Re: Need Circuit Design -- Cheap...

Source: <http://sci.tech-archive.net/Archive/sci.electronics.design/2009-04/msg03741.html>

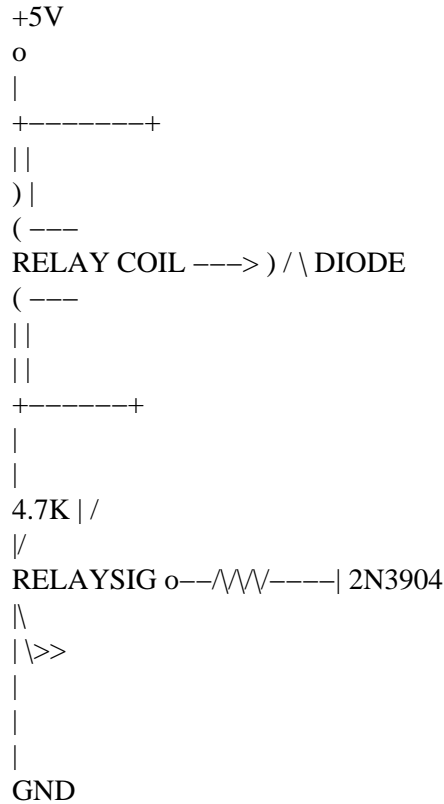
4. Would the relay I use still be be the Hamlin HE721A0500 wired as such: (5DVC Coil voltage)

What are the current requirements for those relays?

I'd probably buffer with an NPN, like this...
